UNITED STATES PATENT AND TRADEMARK OFFICE

APPLICATION NO.	FILING DATE	FIRST NAMED INVENTOR	ATTORNEY DOCKET NO.	CONFIRMATION NO.
09/493,692	01/28/2000	Bahram Javidi	98-2091	2545
23413	7590	07/18/2005	EXAMINER	
CANTOR COLBURN, LLP 55 GRIFFIN ROAD SOUTH BLOOMFIELD, CT 06002			LAVARIAS, ARNEL C	
			ART UNIT	PAPER NUMBER
			2872

Office Action Summary	Application No.	Applicant(s)	
	09/493,692	JAVIDI, BAHRAM	
	Examiner	Art Unit	
	Arnel C. Lavarias	2872

DETAILED ACTION

FIG. 12A

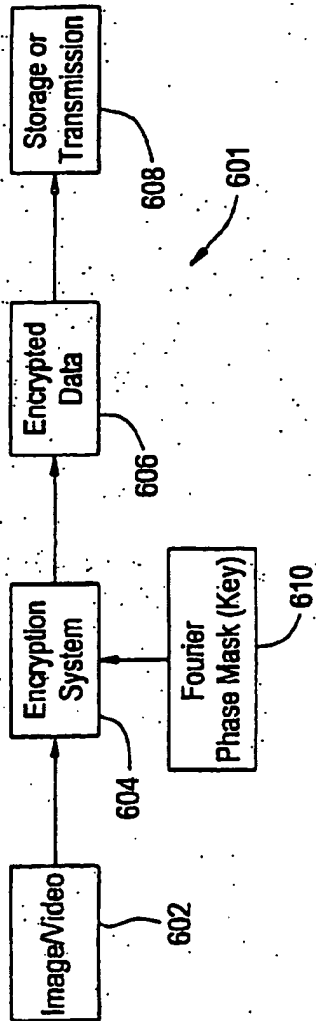
2. The drawings are objected to as failing to comply with 37 CFR 1.84(p)(5) because they include the following reference character(s) not mentioned in the description:

Figure 12A- Reference numeral 601

Corrected drawing sheets in compliance with 37 CFR 1.121(d), or amendment to the specification to add the reference character(s) in the description in compliance with 37 CFR 1.121(b) are required in reply to the Office action to avoid abandonment of the application. Any amended replacement drawing sheet should include all of the figures appearing on the immediate prior version of the sheet, even if only one figure is being amended. Each drawing sheet submitted after the filing date of an application must be labeled in the top margin as either "Replacement Sheet" or "New Sheet" pursuant to 37 CFR 1.121(d). If the changes are not accepted by the examiner, the applicant will be notified and informed of any required corrective action in the next Office action. The objection to the drawings will not be held in abeyance.

FIG. 12B

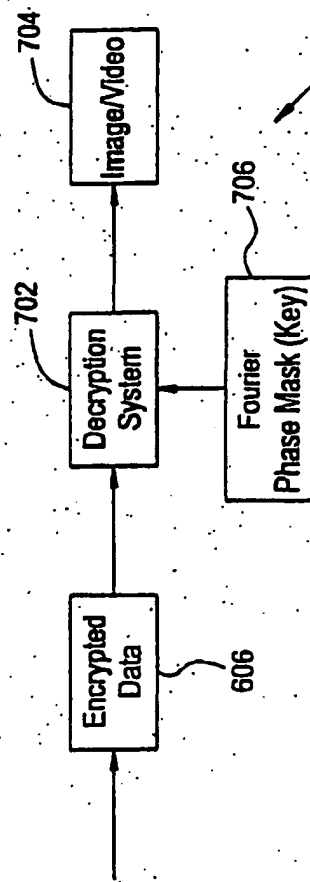
Figure 12B- Reference numeral 701.
